THE ESSELTINE DRAIN: ADDENDUM REPORT—BOOK 3

SECOND ONSITE MEETING 25 JANUARY 2017
LANDOWNER QUESTIONS AND COMMENTS

RC SPENCER ASSOCIATES INC.
Consulting Engineers

Project No.: 14-425

Figure 1: Carolyn Stockwell – Drawing Showing Location of the Esseltine Drain

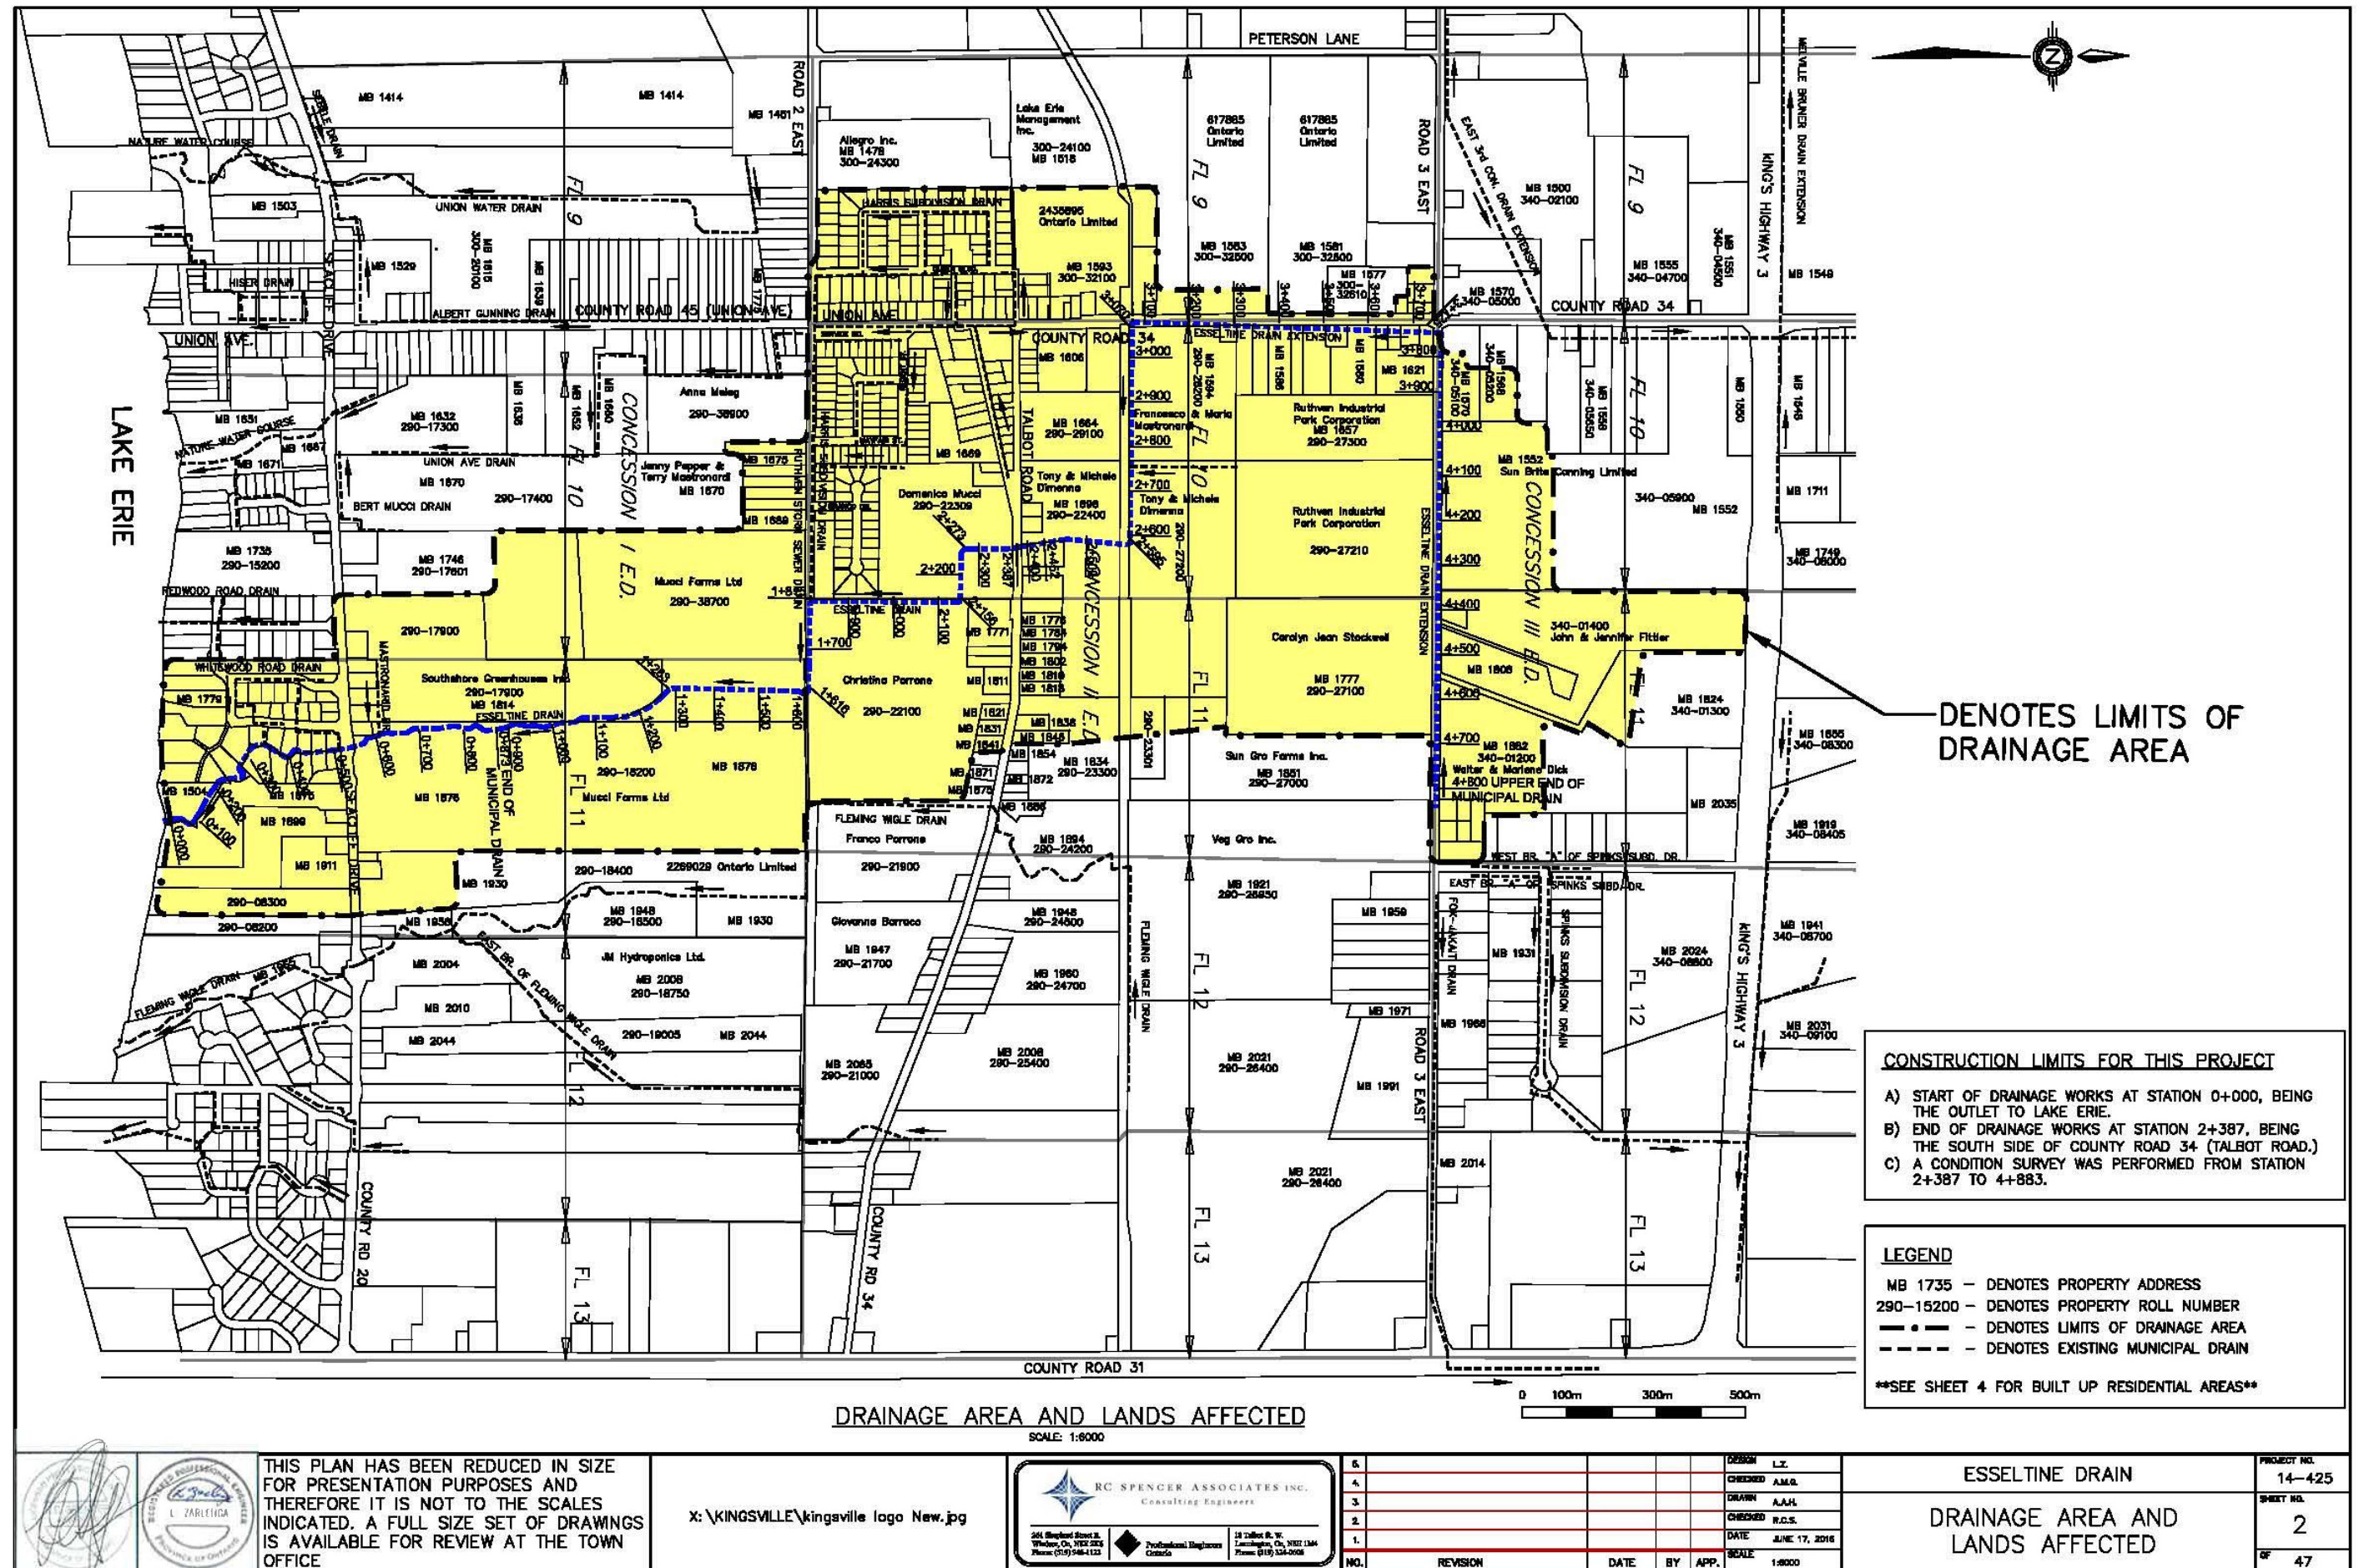
ENTRY NO.	NAME	DATE	LANDOWNER COMMENTS	ENGINEER'S RESPONSE (RC SPENCER ASSOCIATES)
1)	Carolyn Stockwell 1777 Road 3 East Roll No.: 290-27100	January 25, 2017	1) Where is the current location of the Esseltine Drain? 2) We own agricultural land and do not add a lot of flow to this drain. Will future developments pay for their share of this project based on their increased flow? Will we receive a credit payment?	1) We have attached a drawing showing the location of the Esseltine Drain. The drain is shown in the blue dashed line. 2) a) Each property is assessed based on land use, length of the drain being used, and size of your land parcel. b) Properties in the drainage area are only assessed for their current use. - Please see page 10 (Figure 1) for attachment

Figure 2: Fernanda Gillis – Property Drainage Route

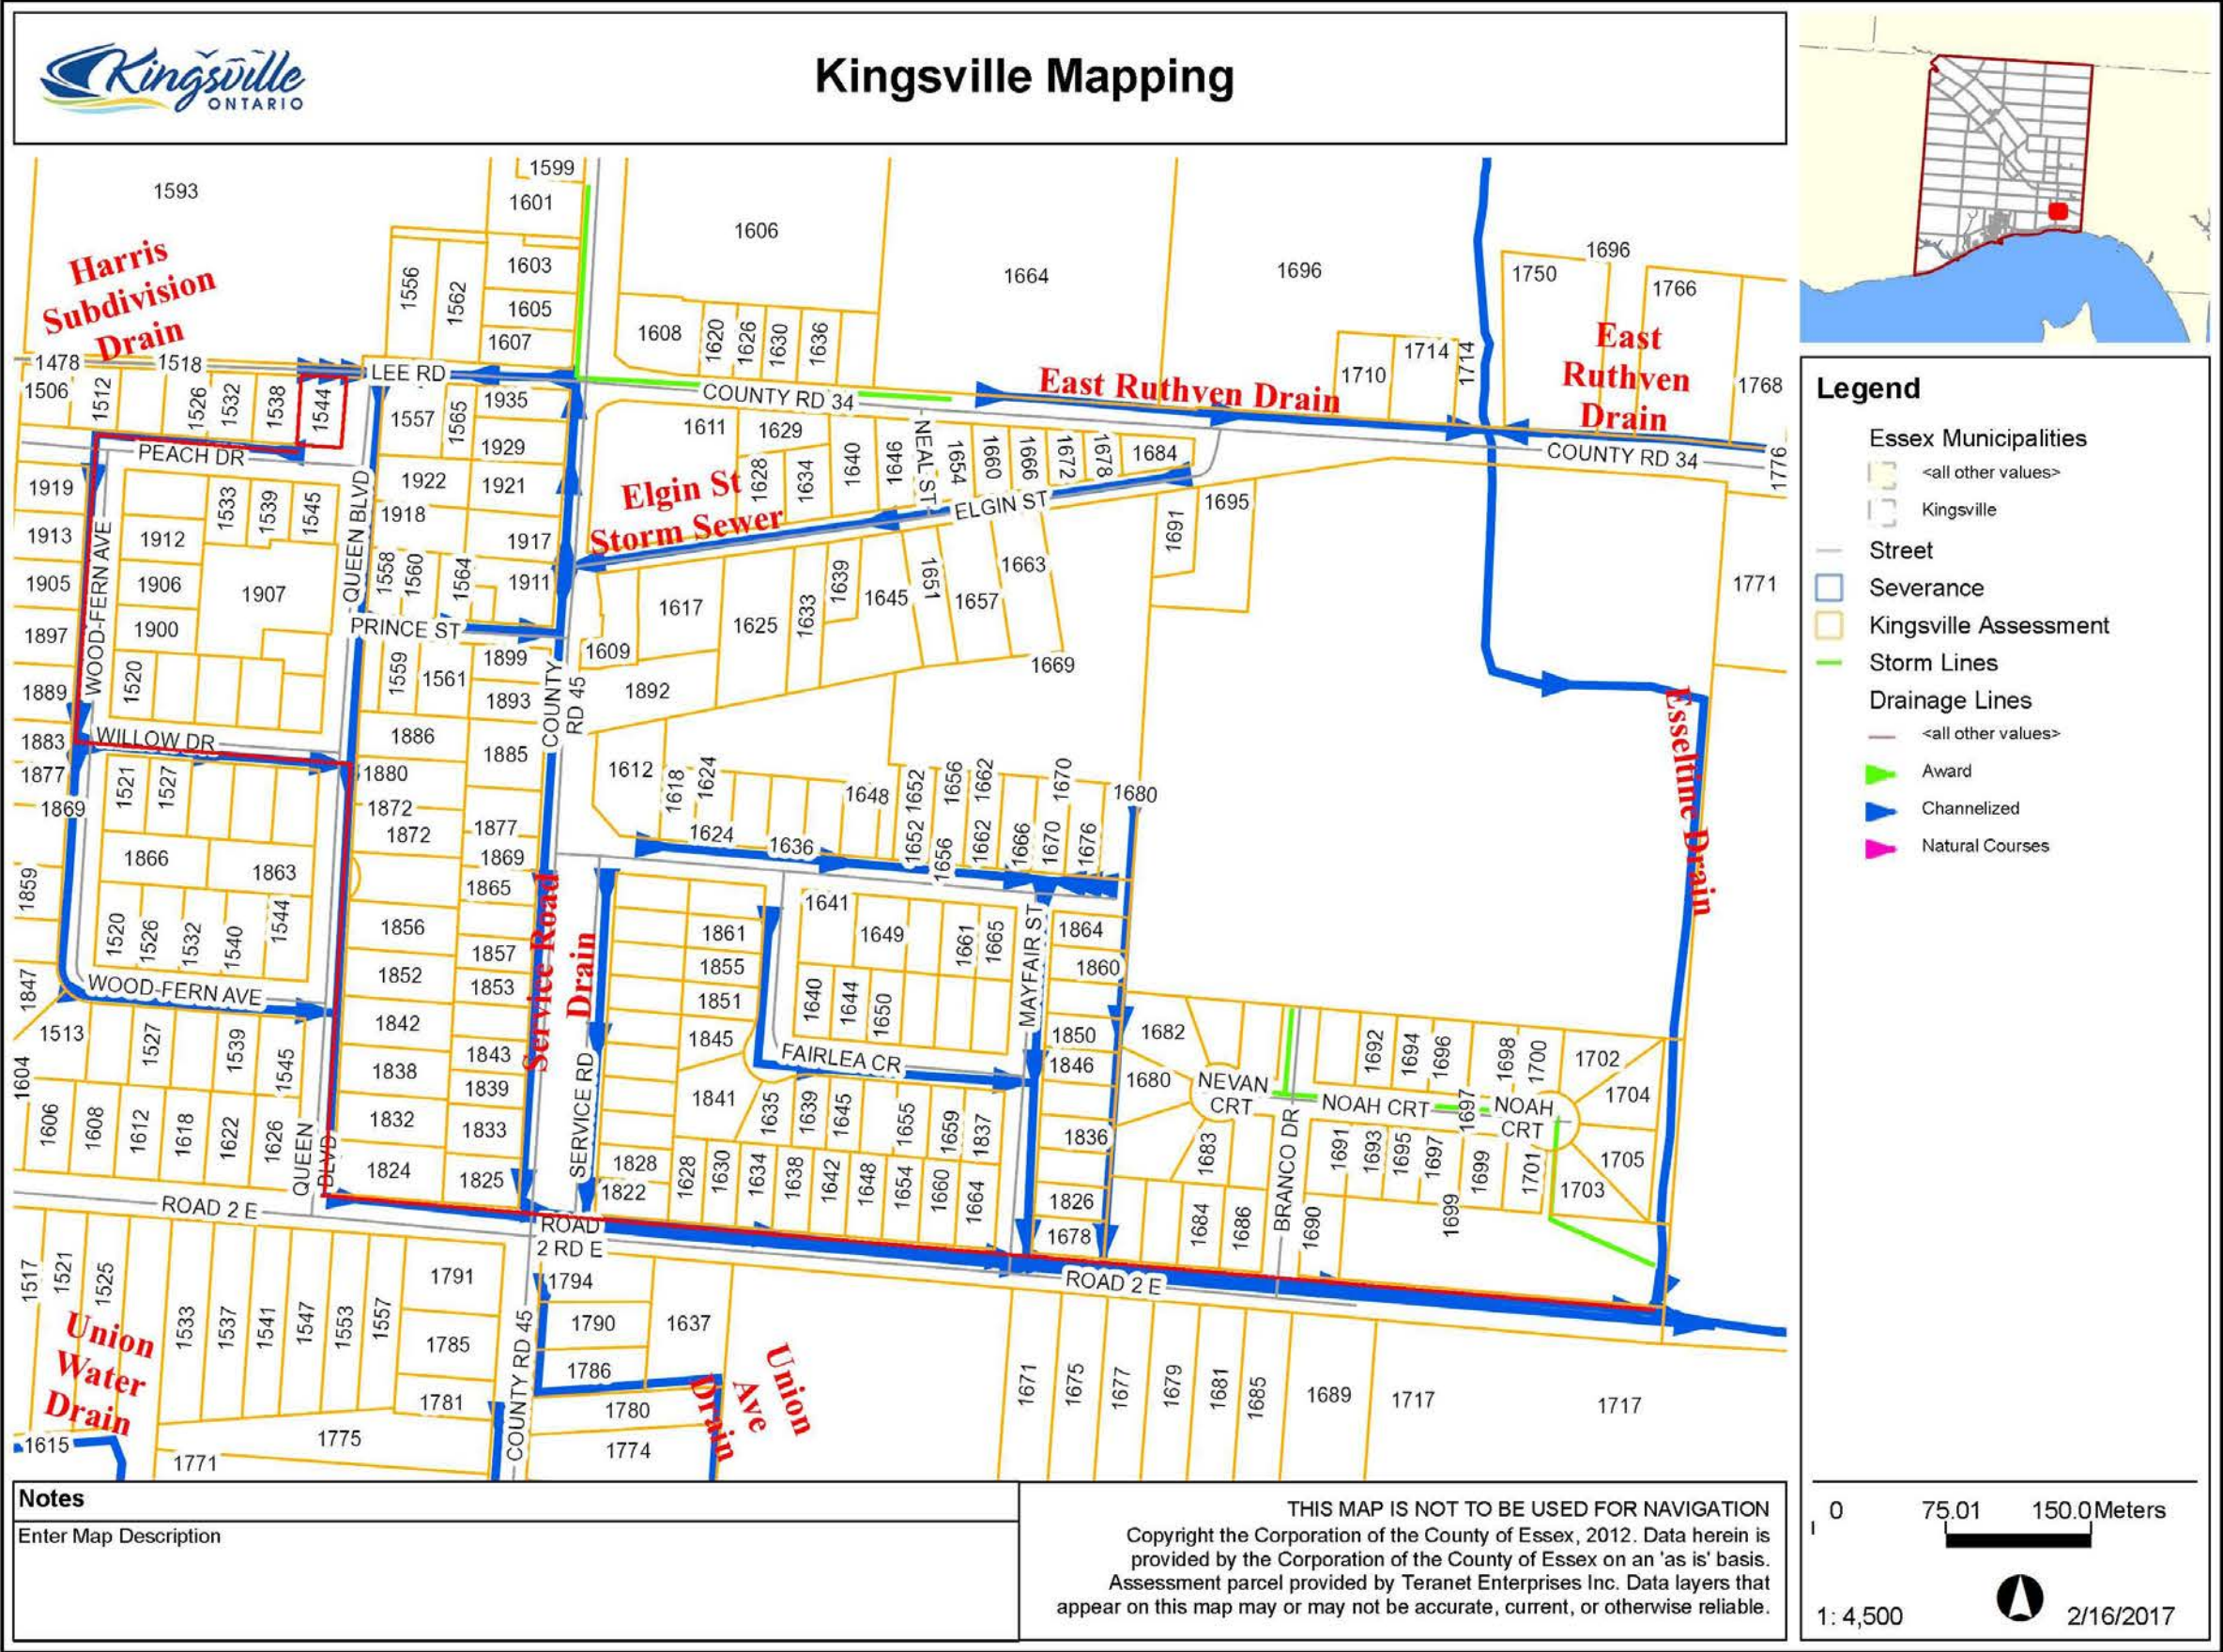
3)	Fernanda Gillis 1544 Peach Drive Roll No.: 300-27400	January 25, 2017	1) Are we draining into Esseltine?	1) Yes, drainage limits have been established. Anyone within the drainage area is under the assessment schedule. 2) We have attached a map showing how your property drains into the Esseltine Drain. Your property (1544 Peach Drive) and the path the water takes into the Esseltine Drain has been outlined in red. Flow arrows are also shown in the municipal drains. - Please see page 11 (Figure 2) for attachment
